STAFF RECOMMENDATION

411 Bushnell Street

June 21, 2017

Application: New construction—addition and outbuilding/detached accessory dwelling unit

Figure 2. Demolition Plan. The hatched portion shows the outline of the addition that has been demolished.

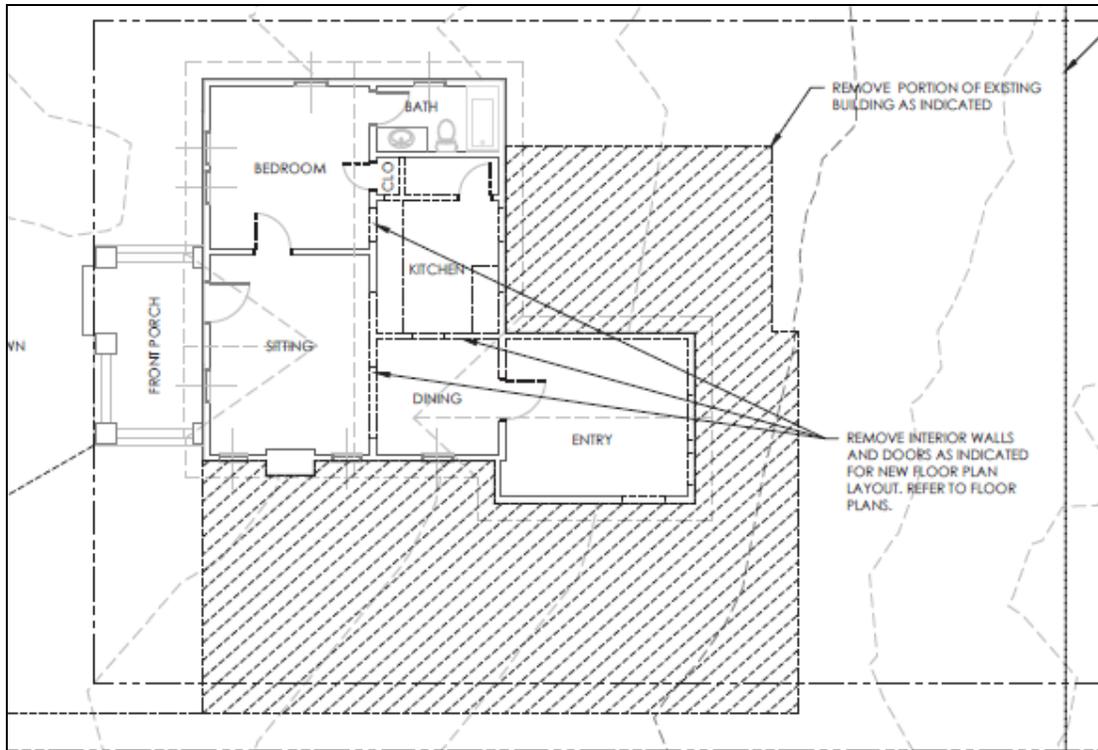
In May 2017, MHZC issued an administrative permit to demolish non-historic portions of the house, including an attached garage on the right side (Figures 2 & 3). The demolition plan indicates that approximately one thousand, one hundred and sixty square feet (1,160 sq. ft.) of non-historic additions were demolished. The remaining house is approximately eight hundred and fifty-three square feet (853 sq. ft.) in footprint. Portions of the addition will be rebuilt, and the foundation for that part remains (Figure 4). Note that the portion that is to be rebuilt is included in the eight hundred and fifty-three square feet (853 sq. ft.) footprint calculation.

S I T E P L A N

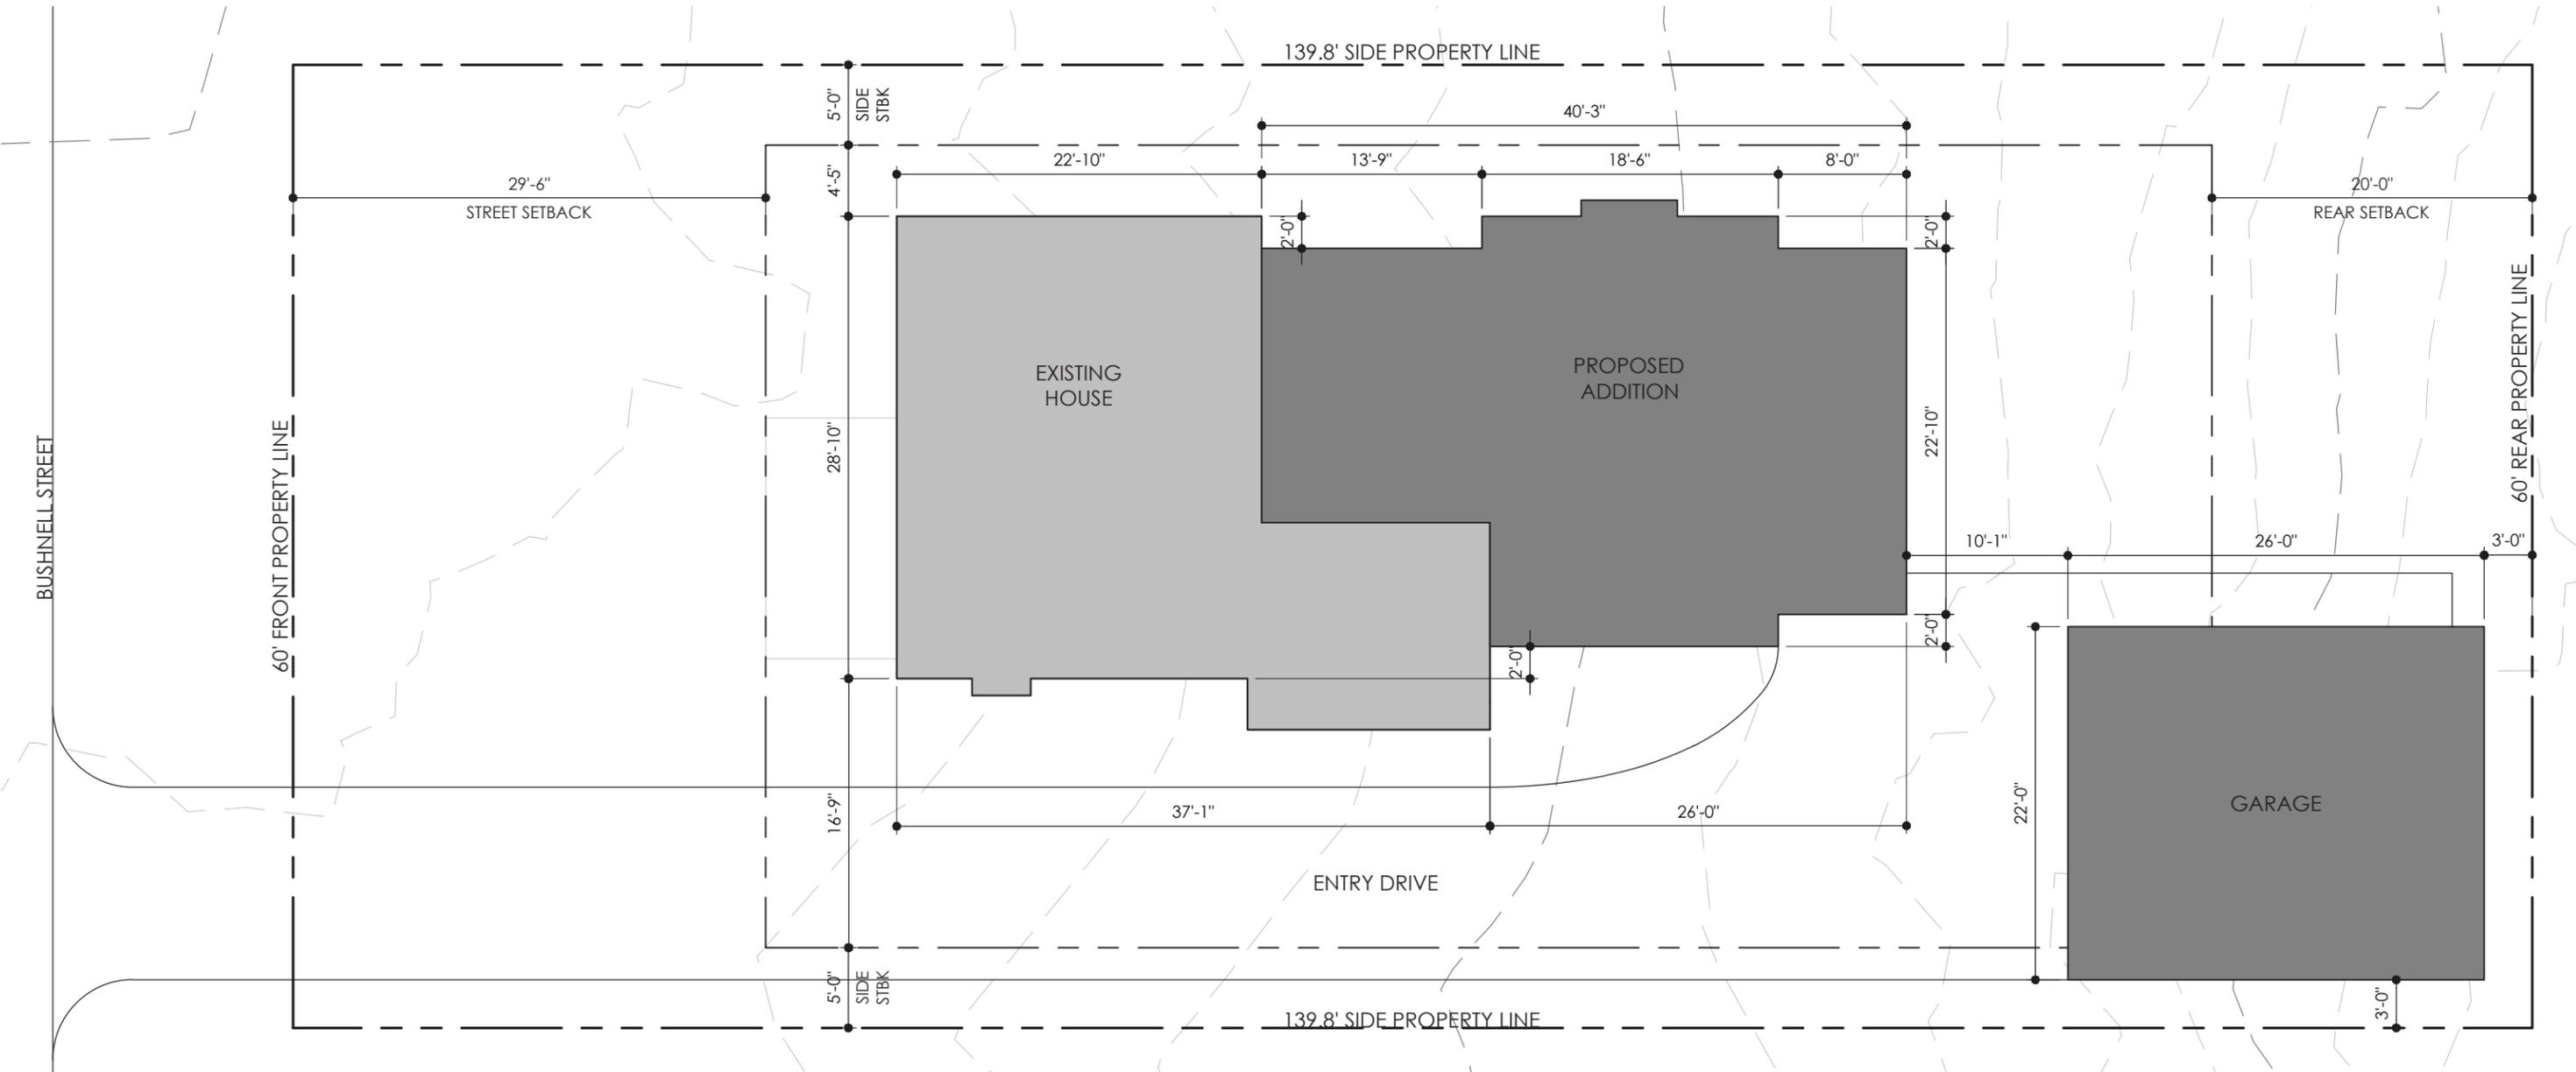
MINIMUM	PROPOSED
Space between principal building and DADU/Garage	20'	10'1"*
Rear setback	3'	3'
L side setback**	3'	35'
R side setback**	3'	3'
How is the building accessed?	From the alley or existing curb cut	Existing Curb Cut

*MHZC typically recommends a minimum of twenty feet (20') in between the back of the house/addition and the outbuilding/DADU. The applicant is proposing just ten feet, one inch (10'1") in between the back of the addition and the DADU. Staff finds the reduced space to be appropriate in this instance because the lot is unusually shallow at less than one hundred and forty feet (140') deep. In addition, because the DADU is shifted to the right side of the lot, there is no overlap in between the back of the addition and the DADU at the ten foot, one inch (10'1") distance. Two feet (2') of the twenty-two foot (22') wide DADU overlap with the addition at a distance of eighteen feet (18') in between the two structures. Another five feet (5') of the twenty-two foot (22') wide DADU overlaps with the addition at a distance of thirty-six feet (36') in between the two structures. The remaining fifteen feet (15') of the DADU's front façade does not overlap with the addition at all.

Staff finds that the proposed DADU meets section II.B.8.b of the design guidelines and 17.16.30.G. 4 of the ordinance.

NORTH + WEST ELEVATION

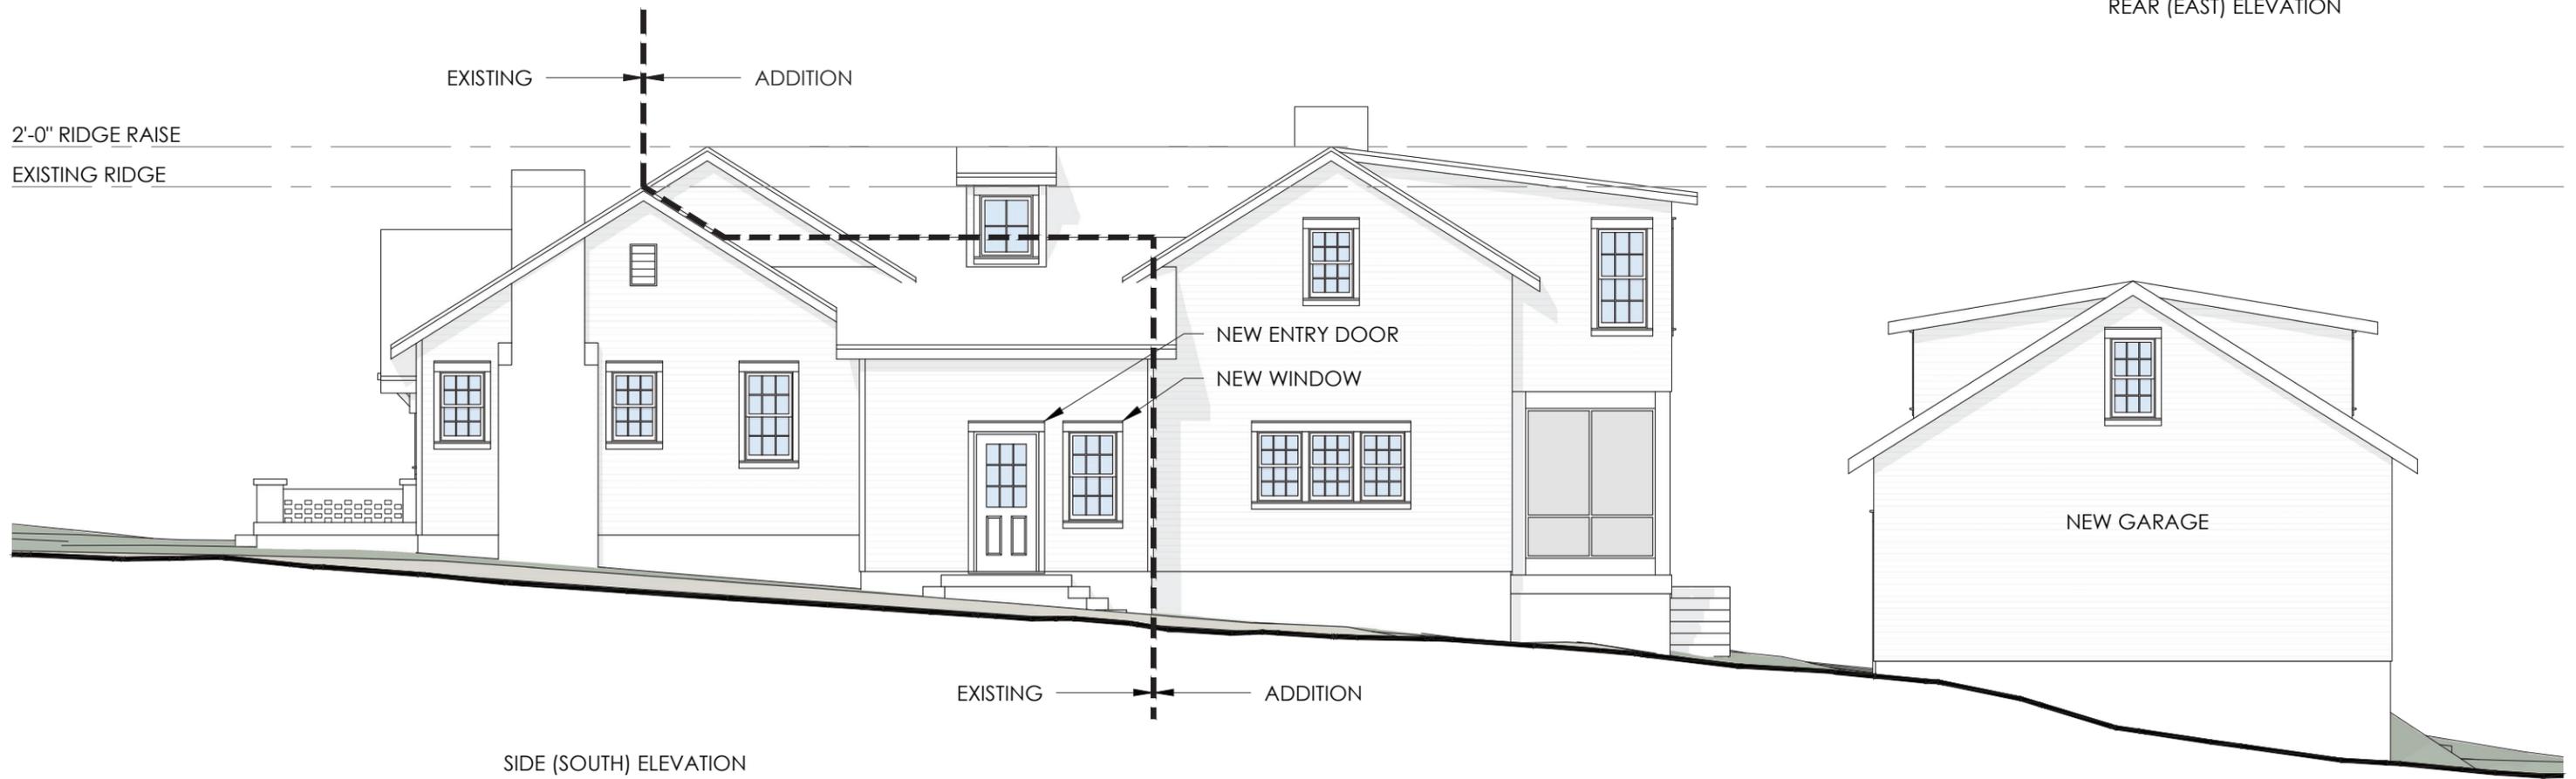
The addition includes a ridge raise that is inset two feet (2') from the side walls of the historic house, which is appropriate. The ridge will be raised two feet (2') vertically, and the addition will continue the height of the ridge raise. The historic house is one story in height. On the right side, the reconstructed part of the addition will be one story, and the

addition, which is thirty-seven feet (37') back from the front wall, is two stories. On the left side, the addition is entirely two stories. Its eave height will be three feet, nine inches (3'9") taller than the eave height of the historic house. Staff finds the two story form to be appropriate in this instance because it is inset appropriately, reducing its visibility from the street.

Roof form: The addition includes a ridge raise to the side gabled house. The ridge raise insets two feet (2') and goes up a maximum of two feet (2') vertically, thereby meeting the design guidelines. The addition will have gabled forms with a 7/12 pitch to match the historic house's gable. The right façade will have a shed dormer that is inset several feet from the wall below. The rear portion of the addition will have a shed roof form. Staff finds that the proposed roof forms meet Section II.B.5. and II.B.10.

Staff finds that the proposed addition meets Sections II.B.1., II.B.2., and II.B.10. of the design guidelines.

GARAGE ELEVATIONS

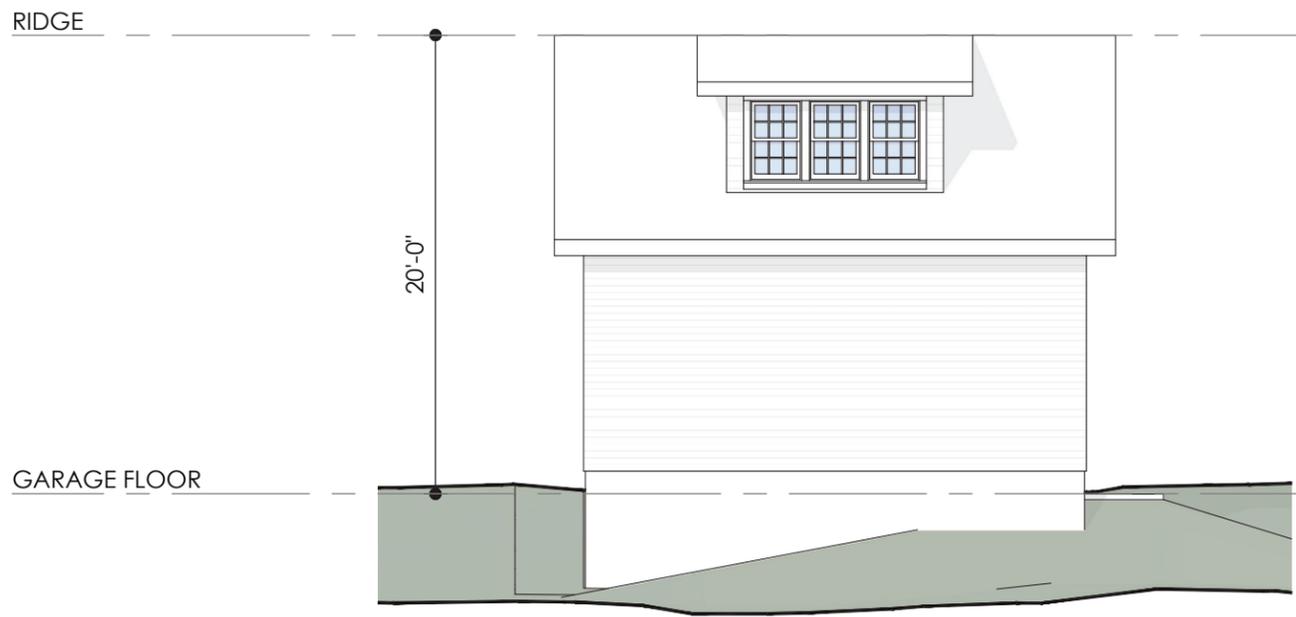
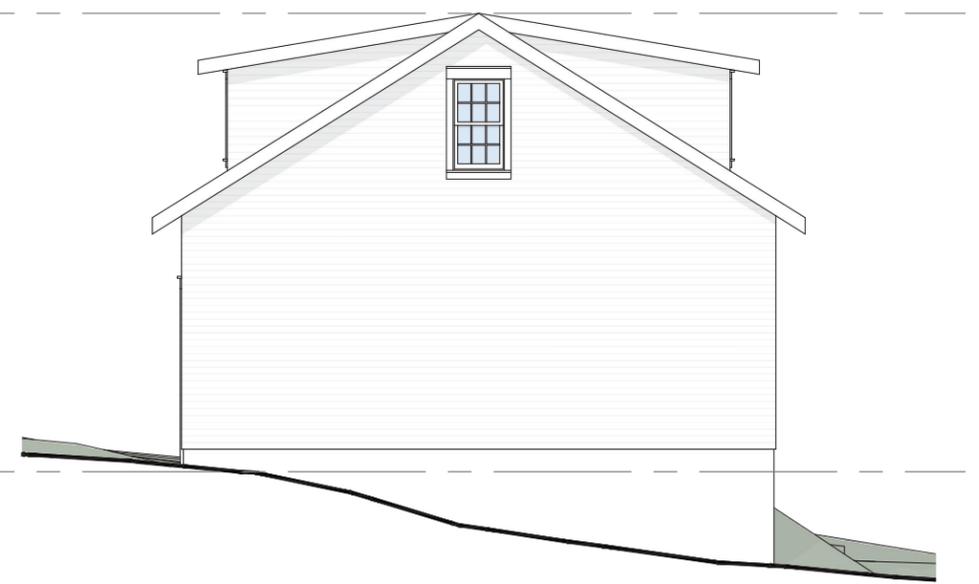
Proposed Element	Proposed Form	Typical of district?
Primary form	Side Gable	Yes
Primary roof slope	8/12	Yes
Dormer form	Shed	Yes
Dormer slope	2/12	Yes

Design Standards: The accessory structure has a simple, utilitarian design that is appropriate for outbuildings. Its roof form, detailing, and overall form do not contrast greatly with the primary structure. The DADU will be visible from the street because it is located to the right of the house. Its visibility will be mitigated by the garage’s location at the rear of the lot and by the slope of the lot, which allows the DADU to sit lower on the lot than the primary structure. Staff finds that the DADU’s design meets Section II.B.8.a of the design guidelines and Section 17.16.030.G.8 of the ordinance.

With the staff’s final approval of the foundation material and the vehicular and pedestrian doors, staff finds that the known materials meet Section II.B.8.a. of the design guidelines.
